August 9, 2019

RE: Adequacy Review 1 for 112 Construction Materials Reclamation Amendment 1 to the Permit, Bernhardt Gravel Mine, Permit M-2002-120; Response

This letter is being generated to satisfy the preliminary review dated June 4, 2019 for the Bernhardt Gravel Mine. The italicized items are the current comment and the bold text are the responses:

Bernhardt Power Line Seismic 42 ft
10 most critical surfaces, MINIMUM BISHOP FOS = 1.518

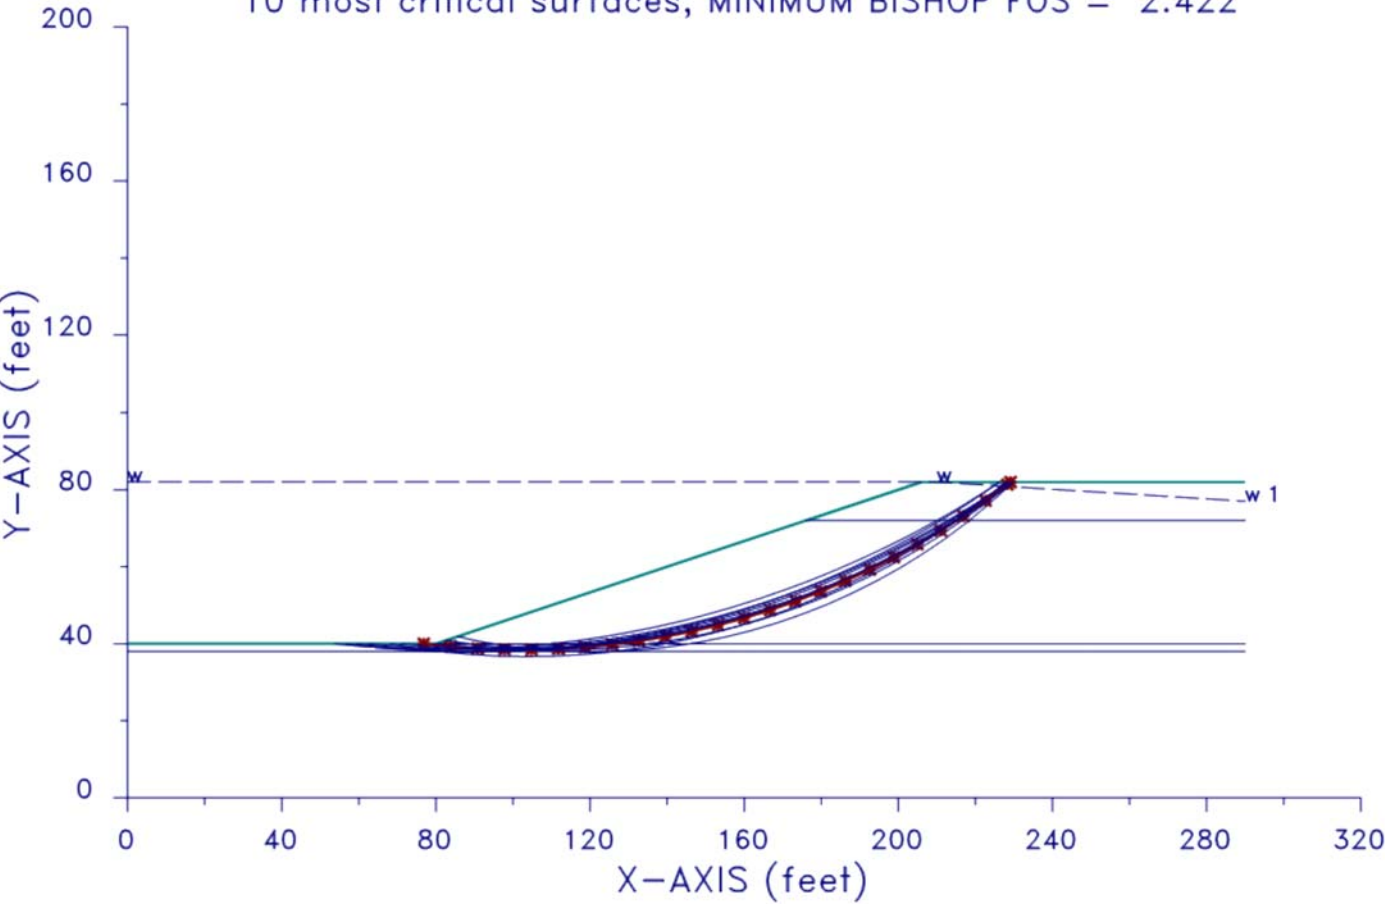
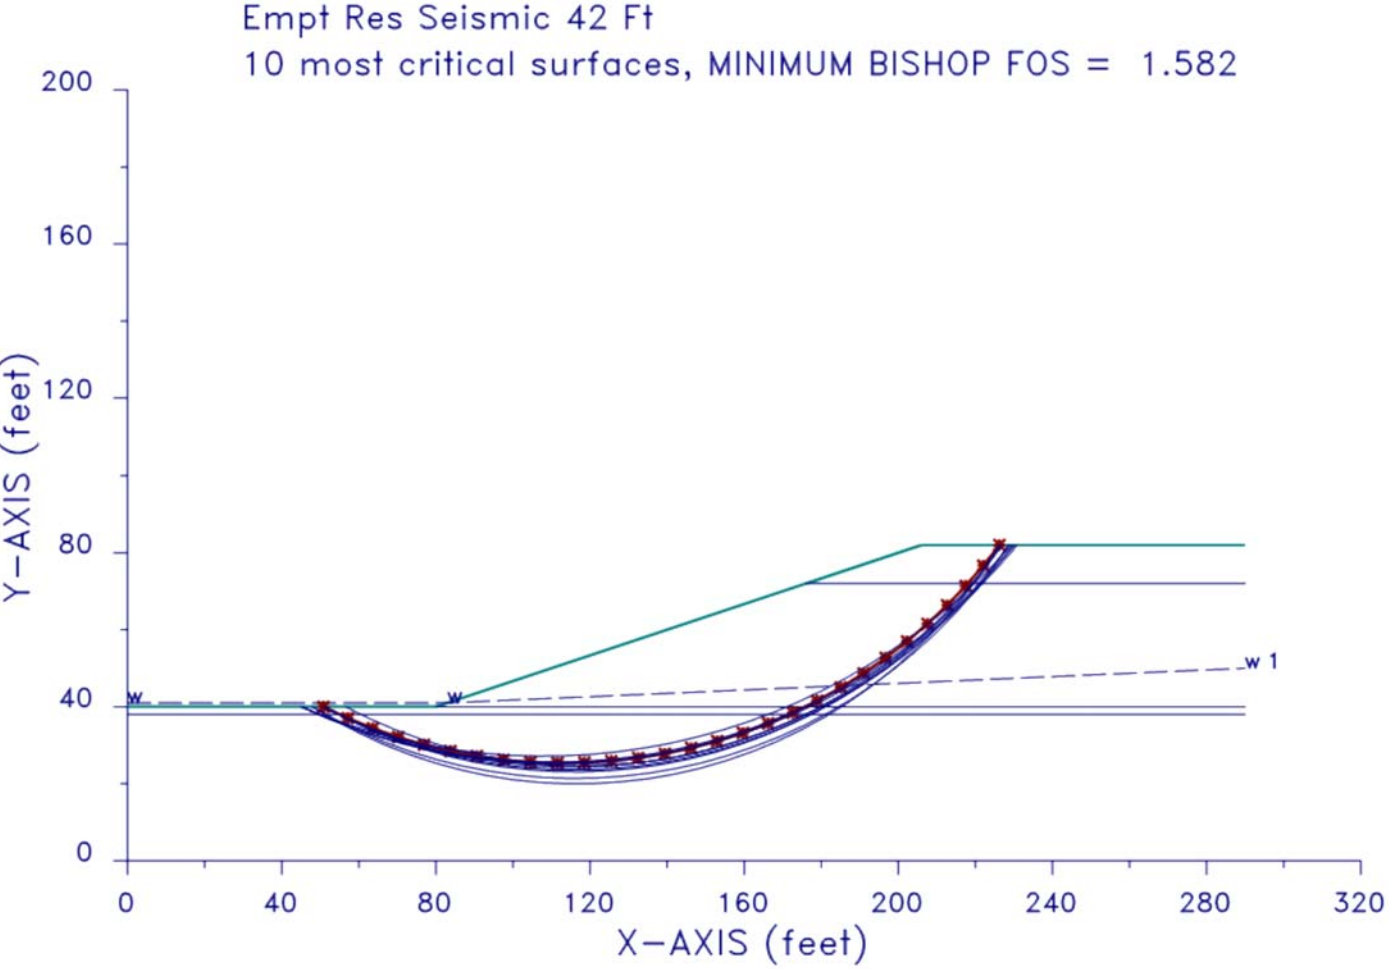
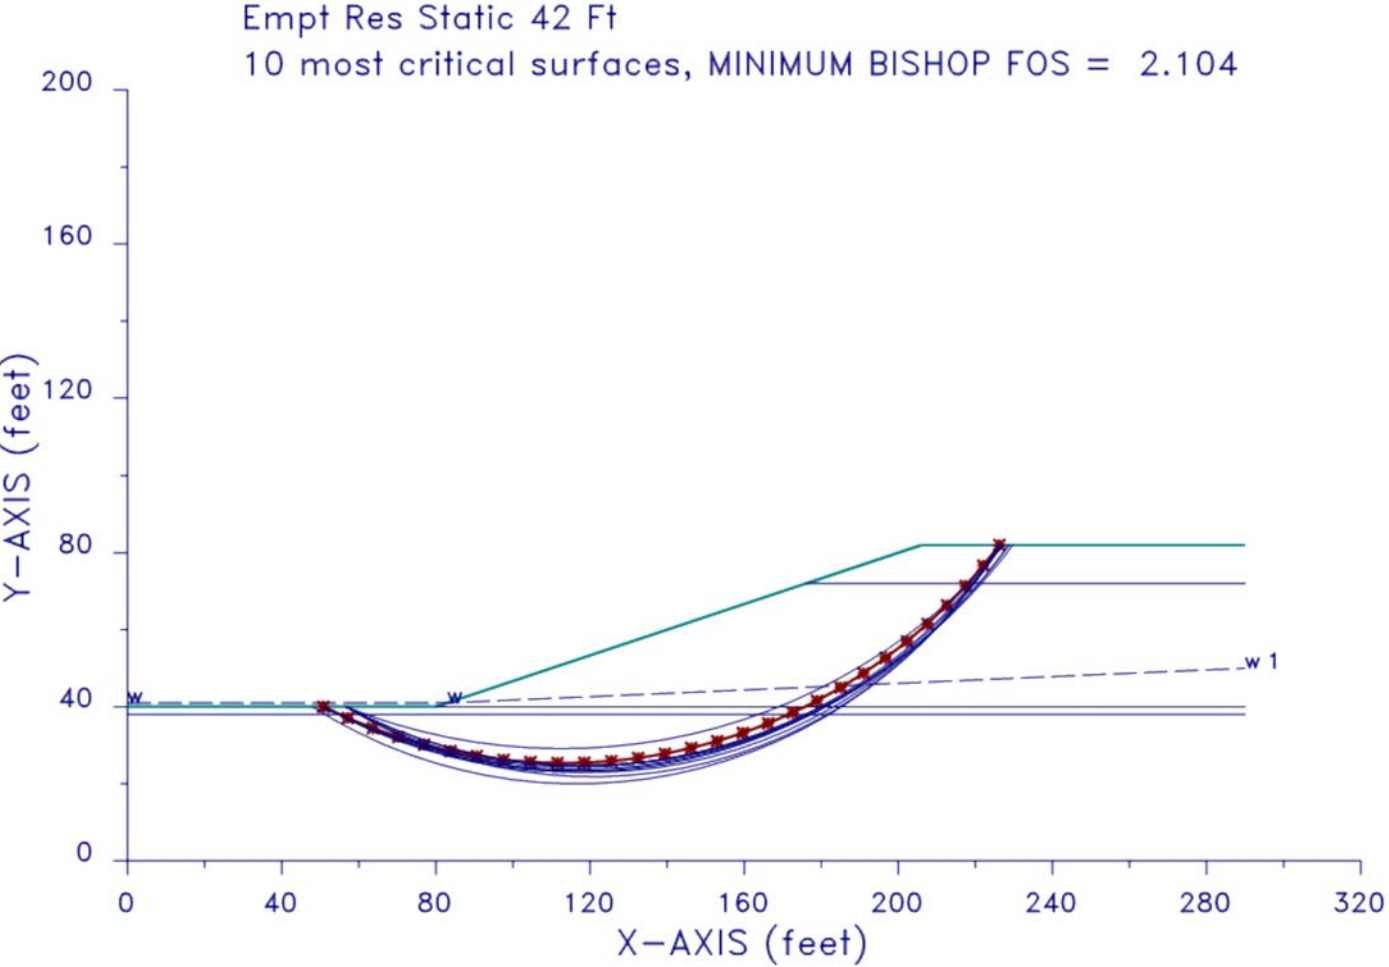
*The Division notes that at this time it appears that mining has taken place well within the approved 55' of the overhead power line that runs through the Cell 2 area. Therefore, the permittee will be required to either immediately obtain an executed damage waiver agreement from the owner of the overhead lines, or backfill the excavation to a minimum distance of 55' from the overhead lines. Permittee should review the setback distance from other structures within and adjacent to the permit to ensure they are in compliance with the 55' required setback. **See response below.***

The original mine plans called for a power line located on the interior of Cell 2 to be removed. Thus the original mine plan did not provide a set back from the power line. The power line was never removed and the mine operator mined to within approximately 23 feet power line. Civil Resources performed new stability analyses (discussed herein) with the 3:1 perimeter mine slope used by the operator. The analyses indicate the power line is stable.
